Application for Variation of Listed Building Consent

Listed Building Consent Ref:	2023/0058
Application Decision Notice Date:	16.03.2023
Additional Listed Building Consent Ref:	2024/0190
Site Address:	Wentworth Castle Gardens, Lowe Lane, Stainborough, Barnsley, S75 3ET
Date:	18.06.2025

1. Proposed Amendments to the Construction Methodology for the Battlement Walls

Updated Structural Engineer Proposals to include concrete kerb

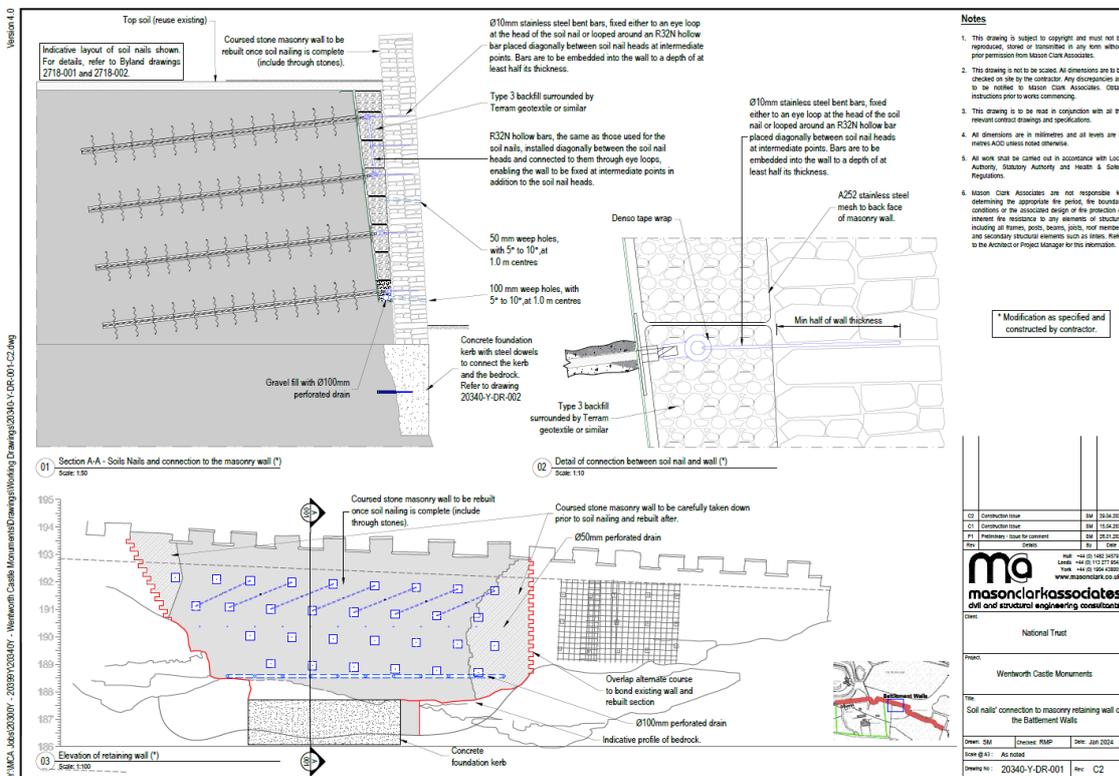
This application seeks approval for a minor amendment to the construction methodology, specifically the introduction of a concrete kerb at the base of a section of the rebuilt wall. This intervention has been necessitated by the discovery of unsuitable bedrock conditions during excavation works.

Following the removal of the collapsed material, a detailed inspection was undertaken by the appointed contractor and structural engineer. It was determined that the original wall had been constructed directly onto bedrock, which in certain areas was found to be inadequate to support the necessary structural loads. To address this issue, it is proposed to install a concrete kerb at the base of the affected section. This kerb will provide a stable and continuous foundation, ensuring the structural integrity of the rebuilt wall. Importantly, the kerb will be installed below the existing ground level and will not be visible upon completion of the works, thereby preserving the visual and historic character of the structure.

Therefore, we recommend casting a concrete foundation curb around the bedrock on the east side of the collapsed wall to confine any fragmented larger blocks of bedrock and provide suitable support for the stone wall. The curb will not be visible once the pre-existing ground level is reinstated.

Proposed concrete kerb

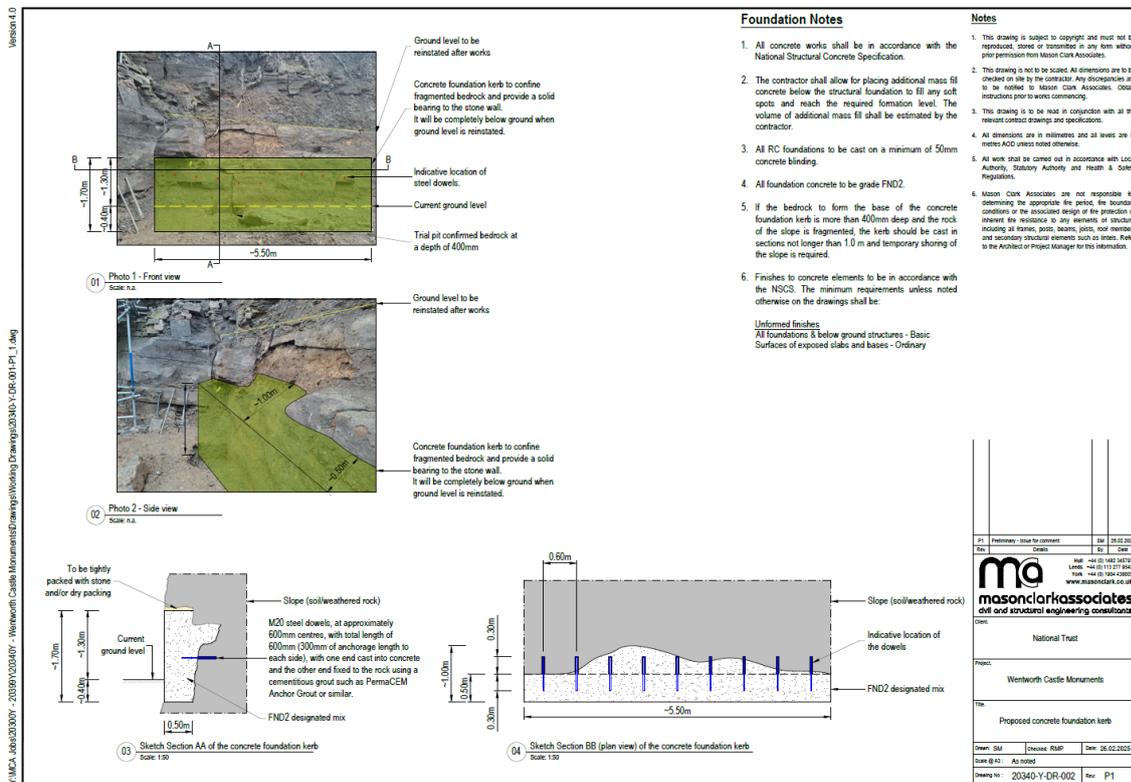
'After clearing the debris over and in front of the slope, it became evident that the existing bedrock to the west was partially fragmented at the base and lacked the necessary continuity to support the stone wall to be built on top of it. In particular, there is a gap in the bedrock to the right of the projecting rock seen on the left in Photo 1, approximately 1.0m wide, which would be difficult to bridge with stonework.

A trial pit revealed bedrock at a depth of 0.40m below the current ground level, which can provide a sound base for the foundation curb. It will have an approximate total depth of 1.70m, of which approximately 0.40m will be below the current ground level, a variable width, with 0.50m in front of the face of the bedrock, and a length of approximately 5.50m. In addition, we recommend the installation of steel dowels to connect the bedrock and the concrete foundation curb.'
